CU Certification of Completion

CU BACKFILL/ENGINEERED CAP COMPLETION APPROVAL - FORM 2						
Reporting Date	11/19/2009				Placement Start Date	10/15/2009
CU Number	3				Placement End Date	11/10/2009
Approximate CU Centroid	Northing	1614048	Easting	736253	NY State NAD 83	
CU Size	4.87	Acres				
Backfill Area	3.55	Acres*				
Cap Area	1.32	Acres				
Backfill Surface Mean Tri+ PCBs Concentration (when required)		NA		mg/kg		
Number of nodes sampled		NA		mg/kg		
Backfill X	Type of Backfill Type 1, Type 2, Nearshore, 15%	Reference to appropriate drawings attached to Approval Form 1 CU3 Backfill and Cap Plan, 10/13/09				
Cap X	Type of Cap Type "A" Low Velocity Cap and Type "A" Medium to High Velocity Cap	Reference to appropriate drawings attached to Approval Form 1 CU3 Backfill and Cap Plan, 10/13/09				
CU Checklist		Indicate one of the following			Reviewer Initial Acceptance

Narrative Summary of Backfill and Capping and EPA Backfill and Capping Agreements

CU03 - POST BACKFILL PLACEMENT
HUDSON RIVER, NEW YORK
HUDSON RIVER SEDIMENT REMEDIATION PHASE 1 PROJECT

CU3
TYPE "A" CAP
ACCEPTANCE SURVEY

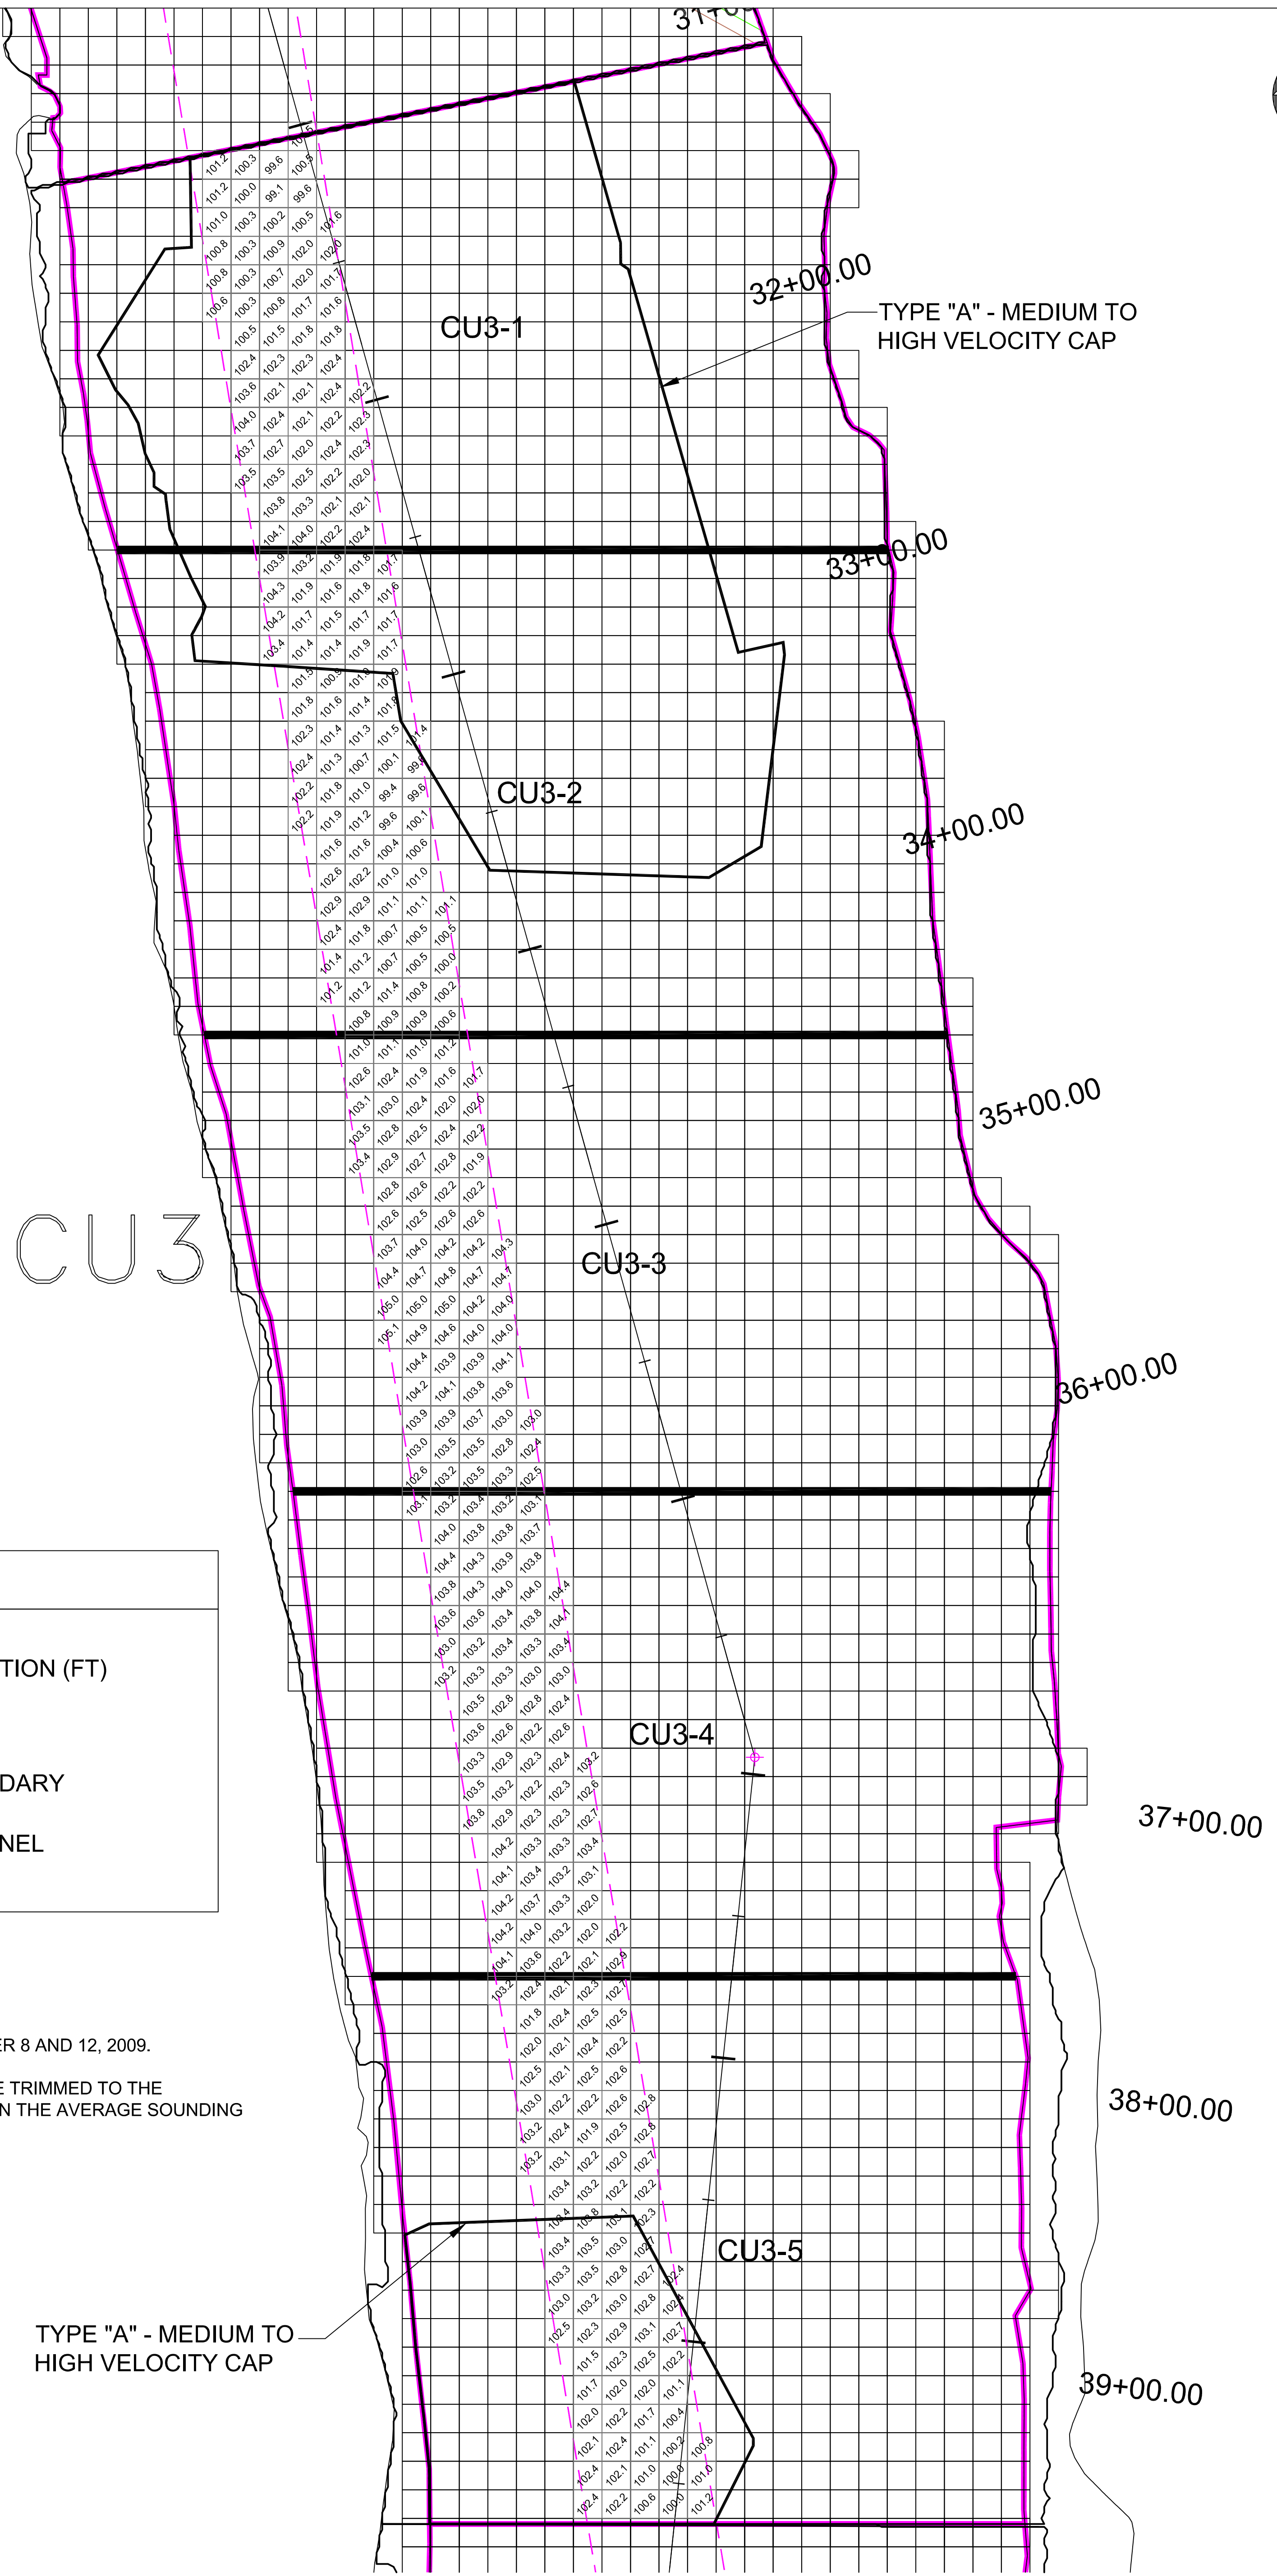
Cap Acceptance Survey Drawing during the meeting of November 12, 2009. EPA accepted that the top of cap and backfill elevations were acceptable (see attached e-mail, dated November 14, 2009). The CU3 Type "A" Cap Acceptance Survey Drawing, dated November 17, 2009 is included in this package.

In CU3 it was agreed that the top of cap and backfill elevations were acceptable, it was discussed that GE was in the process of placing backfill in an area of the navigation channel where the post dredge elevations were below 102' elevation. Once GE has surveyed that additional backfill location GE will prepare a Form 2 package for EPA review.

Andrew, I agree with summary.

**CU4
1 FOOT BACKFILL, 15% BACKFILL, AND
NEARSHORE PLACEMENT
ACCEPTANCE SURVEY**

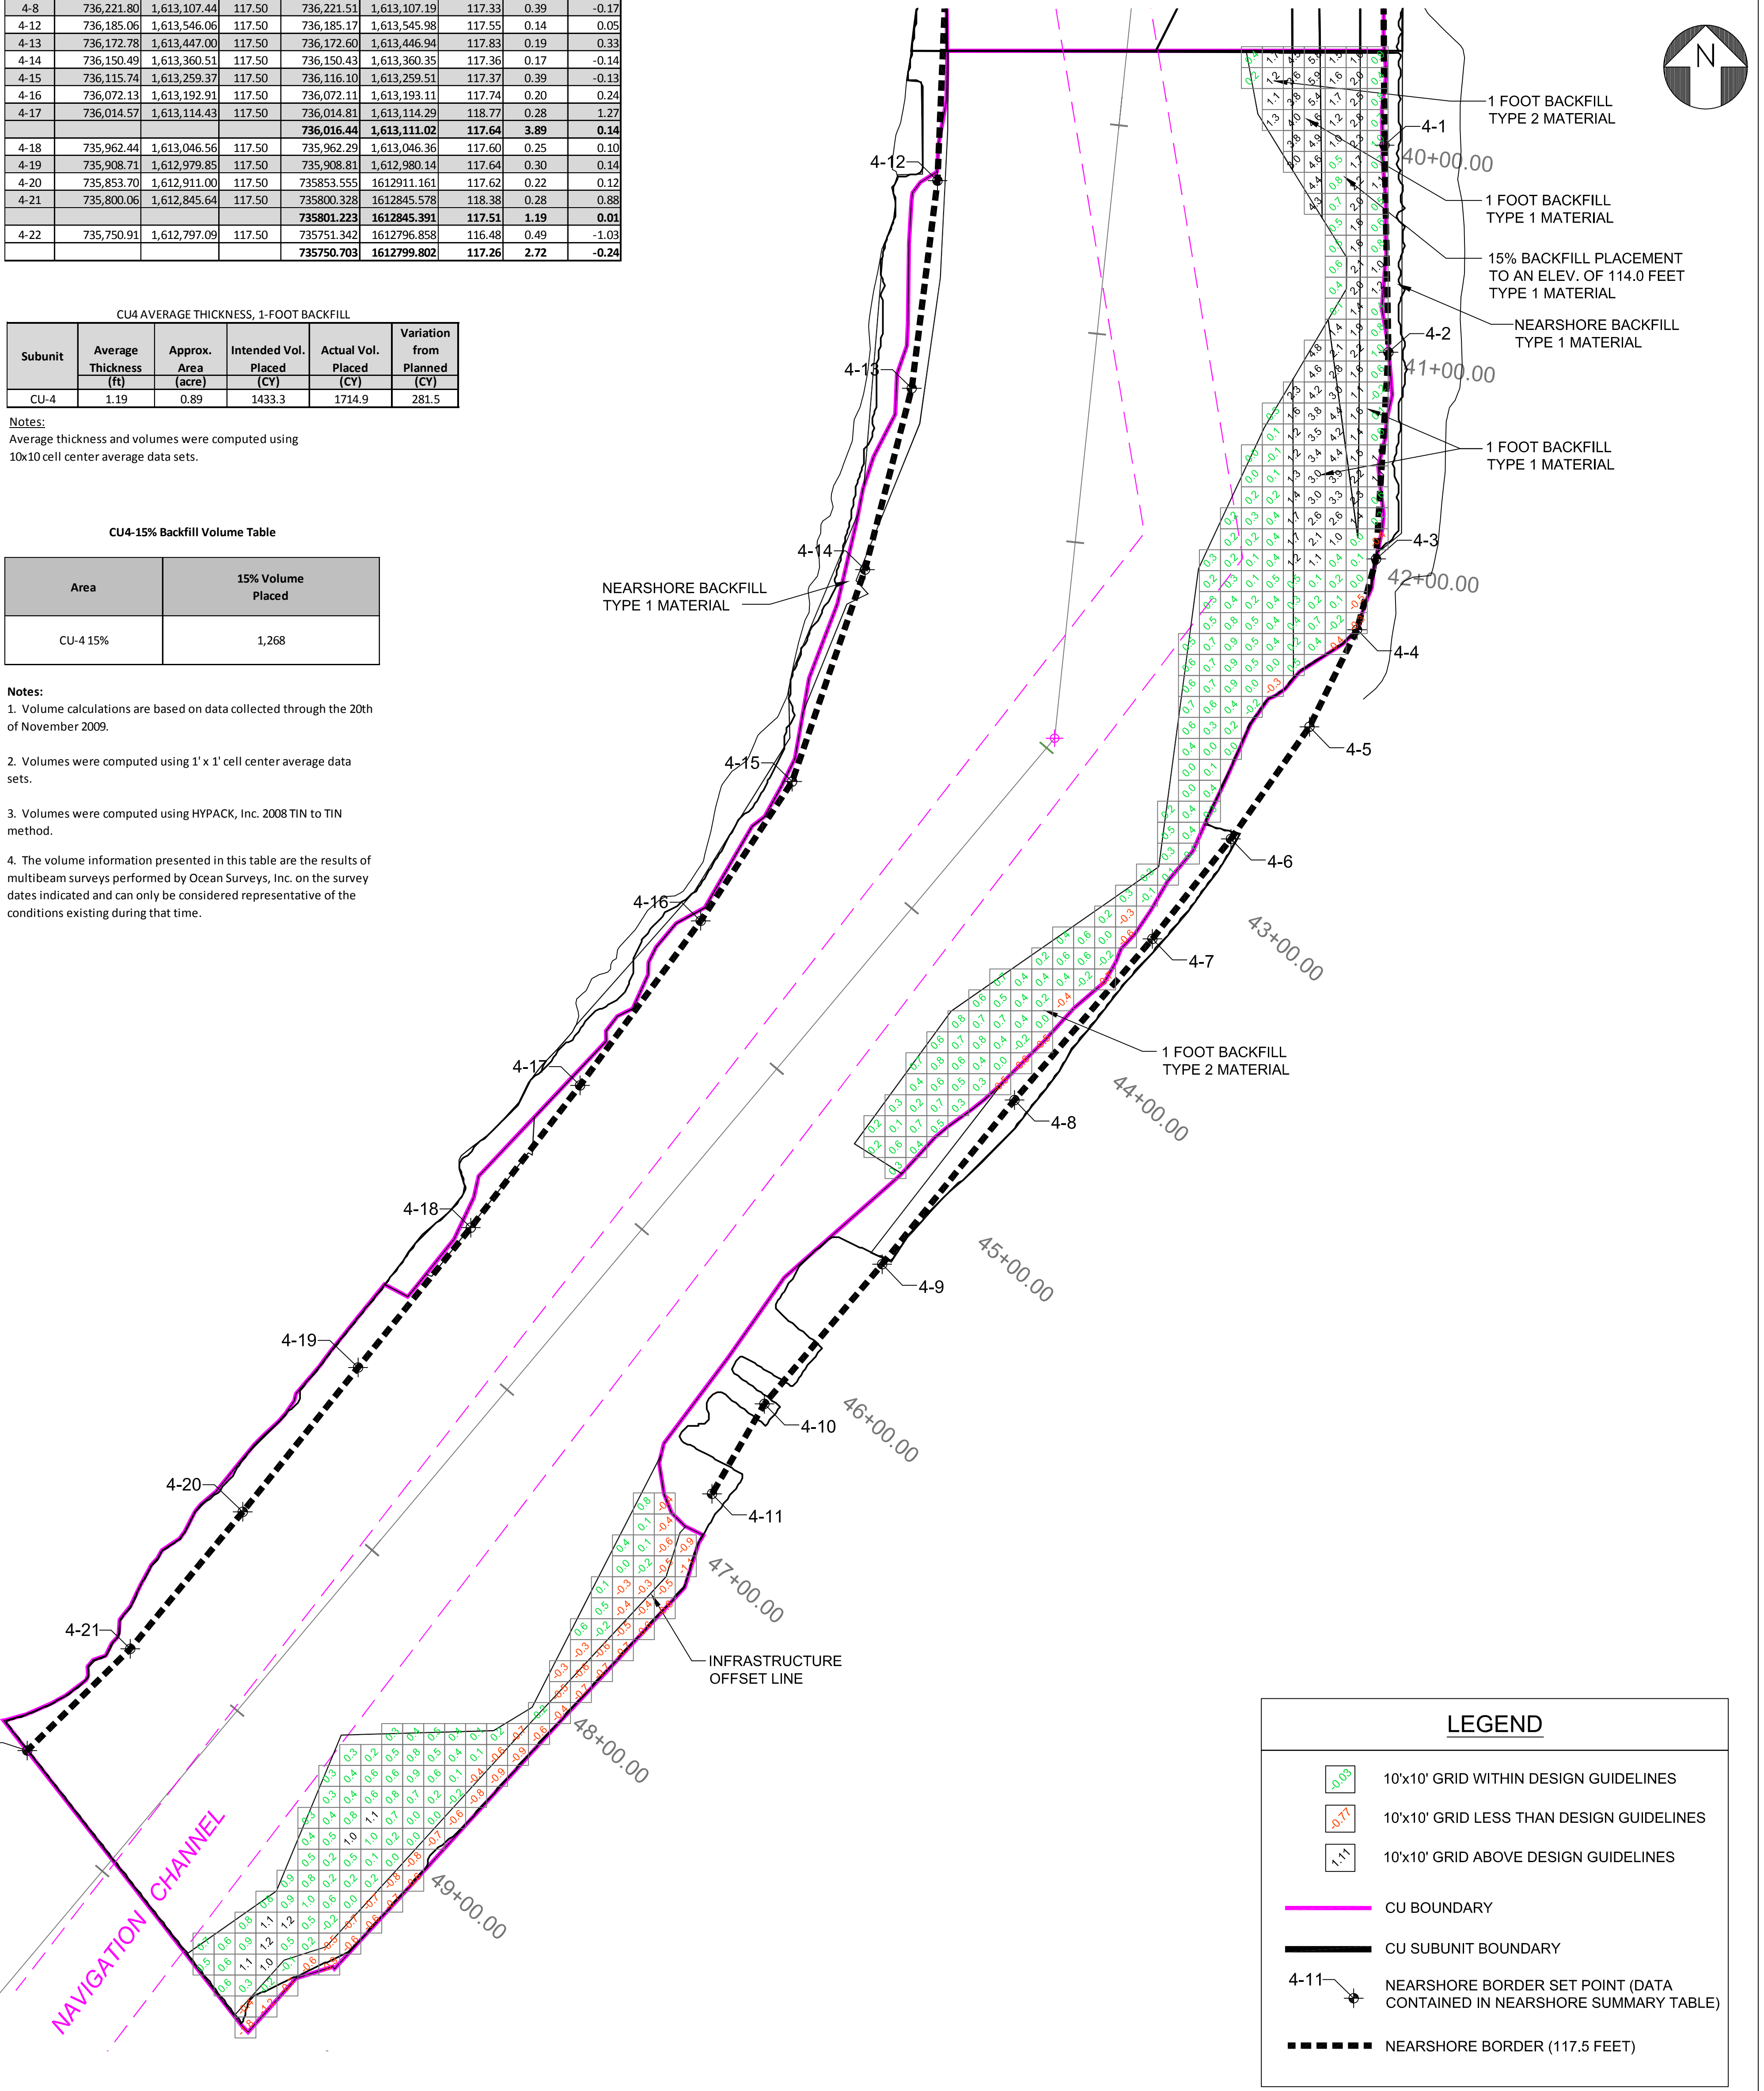
4. Final backfill and armor layer placement surveys for CU 4 Type B Caps were provided to EPA on November 23, 2009. EPA agreed that the final backfill and cap surveys were acceptable, as shown, on November 24, 2009.

Andrew,
The depth in the channel looks good. given the slope stability issue the caps are acceptable. Have the shoreline materials been placed yet?
There has been a change of plans so I will be in the office on Tuesday until 4 PM if you want to sign off on form 2.
